## ***Interactive comment on “Advancements, measurement uncertainties, and recent comparisons of the NOAA frostpoint hygrometer” by Emrys G. Hall et al.***

Review report on "Advancements, measurement uncertainties, and recent comparisons of the NOAA frostpoint hygrometer" by Hall et al.

**Fig. 1.** We have added this as Figure 2 to the paper as suggested by the referee.

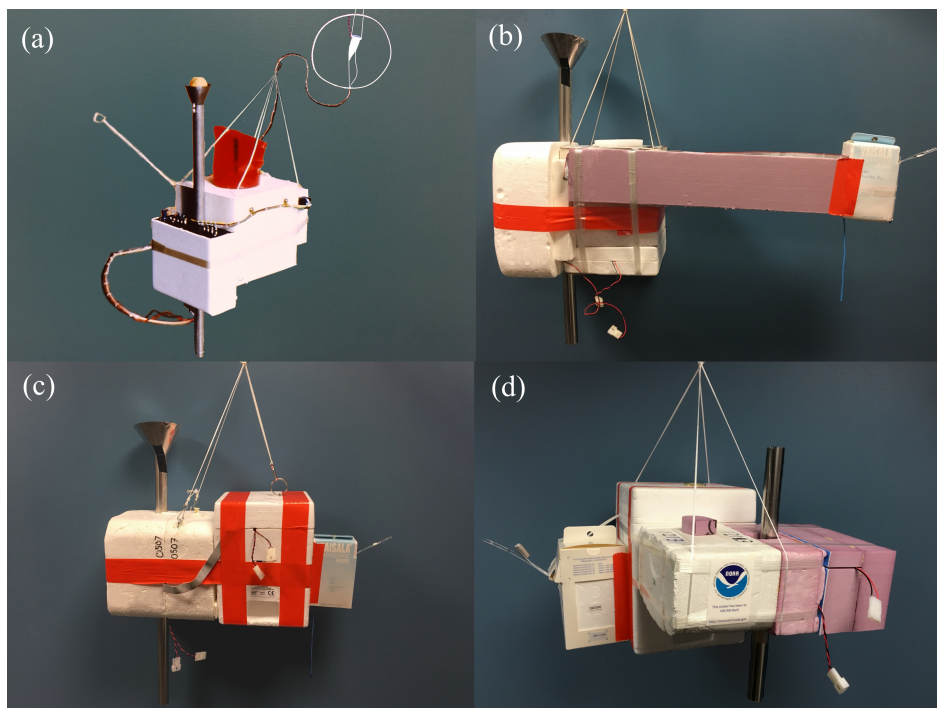
Pages 4-5, Sections 2.1-2.4. It would be very useful to show a photograph of each version together with the combined radiosonde.

Author's response: We have added figure 2 showing all four versions of the NOAA FPH throughout the ongoing 36 year record along with their accompanying radiosonde in a four paneled photograph (see attachment).
